# Access Compliance Report

## Public Rights-of-Way

Intersection ID: 54401	Main Street: LOMA_LINDA_LN	Cross Street: AVENAL_LN	Location: NW
ADA ID: 15BB7E7B576C	Ramp Type: Perp	Initial Pass/Fail: Fail	Overall Compliance: No
Severity Score: 8.75			
Codes/Mitigation Info/Possible Solution		Field Measurements/Component Compliance

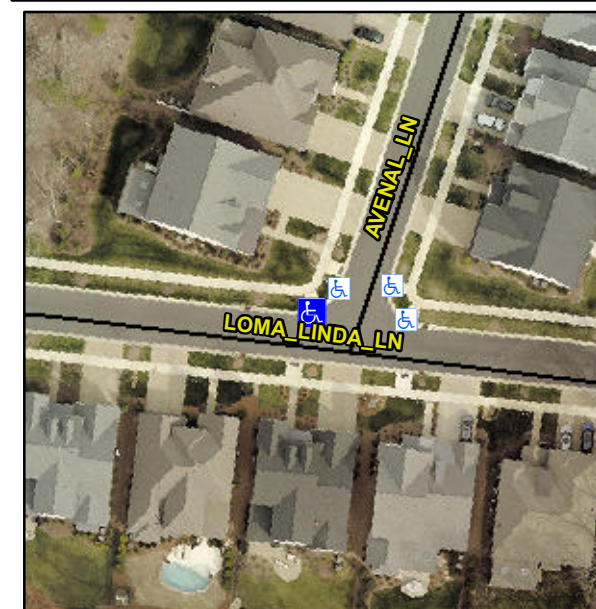
**Remove & Replace Entire Ramp.**

**R304.5.1**

Compliance	Description	Data	Compliance	Description	Data
N/A	Ramp Length (in)	94.5	Yes	Ramp Slope (%)	6.5
No	Ramp Width (in)	47.5	Yes	Ramp XSlope (%)	1.3
N/A	Flare Type LT	N/A	N/A	Flare Type RT	N/A
N/A	Flare Slope LT (%)	N/A	N/A	Flare Slope RT (%)	N/A
N/A	Flare Traversable LT?	N/A	N/A	Flare Traversable RT?	N/A
N/A	Landing Length (in)	N/A	N/A	DWS Provided?	N/A
N/A	Landing Width (in)	N/A	N/A	DWS Contrast?	N/A
N/A	Landing Slope (%)	N/A	N/A	DWS Length (in)	N/A
N/A	Landing X Slope (%)	N/A	N/A	DWS Full Width?	N/A
N/A	Landing Curb? (Y/N)	N/A	N/A	DWS Offset (in)	N/A
N/A	Shared Landing?	N/A			
N/A	Gutter Ponding?	N/A	N/A	Gutter Slope (%)	N/A
N/A	Gutter Lip Ht (in)	N/A	N/A	Gutter X Slope (%)	N/A
N/A	Painted X Walk1?	No	N/A	Painted X Walk2?	N/A
	X Walk 1 Direction	To S		X Walk 2 Direction	N/A
N/A	X Walk 1 Width (in)	N/A	N/A	X Walk 2 Width (in)	N/A
	X Walk 1 Slope (%)	2.1		X Walk 2 Slope (%)	N/A
	X Walk 1 X Slope (%)	2.7		X Walk 2 X Slope (%)	N/A
